**FUJITSU GENERAL AMERICA, INC**

**SERVICE BULLETIN**

Number: 0009

MODEL : AOU18/24/36RLX,  
AOU24/36RML, AOU24CL/RL/RLQ

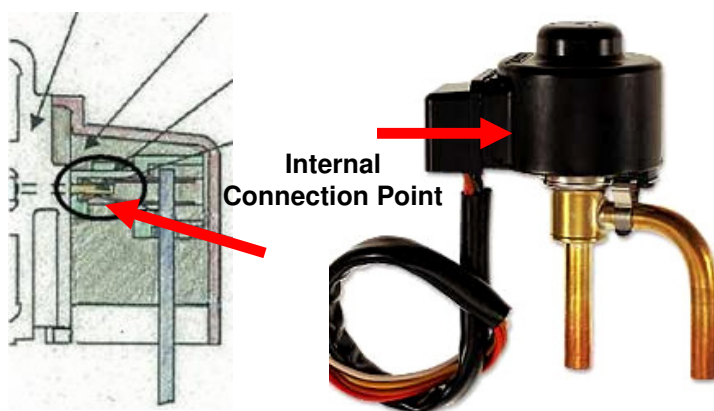
Poor connections of wire harness in the EEV cover.

The mixture of epoxy and stiffening materials in the EEV cover, which fix the connector and wires at the FUJIKOUKI Electronic Expansion Valve, did not have the correct mix ratio. Because the ratio was incorrect, depending on the temperature, the wires would separate internally from the coil preventing the EEV from opening or closing.

Replace with new Electronic Expansion Valve (EEV)
